**Informal Group on gtr No 9 – Phase 2 (IG GTR9-PH2)
8th meeting, Paris/France, 9 – 10 September 2013**

FlexPLI Version GTR Testing of Vehicles with Different Bumper Systems

Presented by the pedestrian safety experts of the
International Organization of Motor Vehicle Manufacturers (OICA)

BL0 Section view

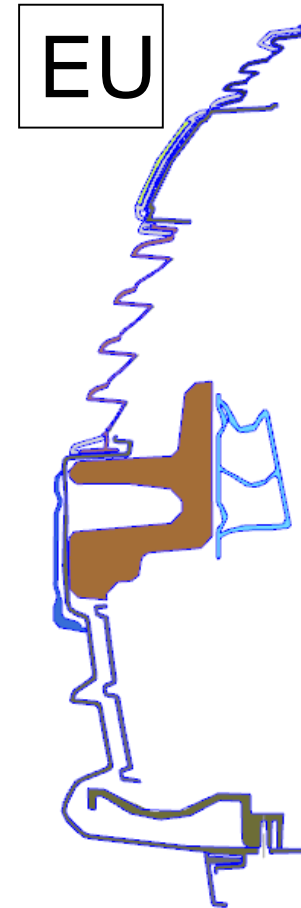
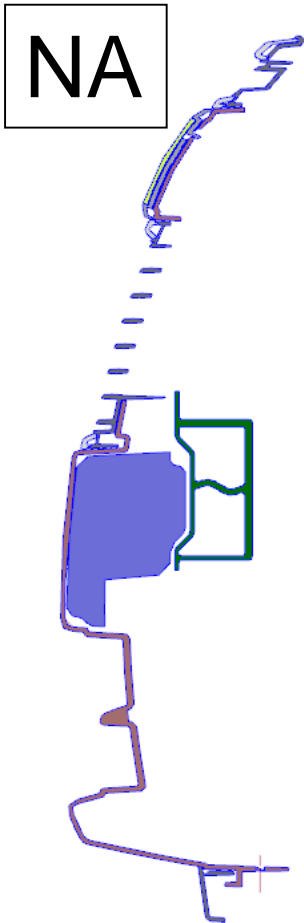
- Shape explains that the EU bumper system was attached to the NA vehicle for the testing
- While this is physically possible, OEM's confirm that EU vs. NA vehicles have – despite of their similar appearance – also significant differences in the front end styling and structure
- These differences are applied to assure that vehicles meet the different requirements in their target markets: for pedestrian safety in the EU on one hand and for the NA bumper requirements on the other hand
- Testing the vehicles just with a modified bumper system creates test results that may be completely misleading regarding the actual performance of these vehicles
- Furthermore, OEM's still strongly believe that there are significant target conflicts in the design directions for the two requirements (pedestrian safety vs. bumper requirements)

- Differences between the EU and the NA vehicles affect:
 - The bumper system (such as the energy compensating foam, the presence of a lower support, etc.);
 - Grille parts (such as size, contour, shape, etc.);
 - Structural parts (such as geometry, position, etc.)
- According to the OEM's experiences, these front end changes influence the performance significantly
- To ensure coherent test results, complete front ends of the vehicles from both markets shall be tested
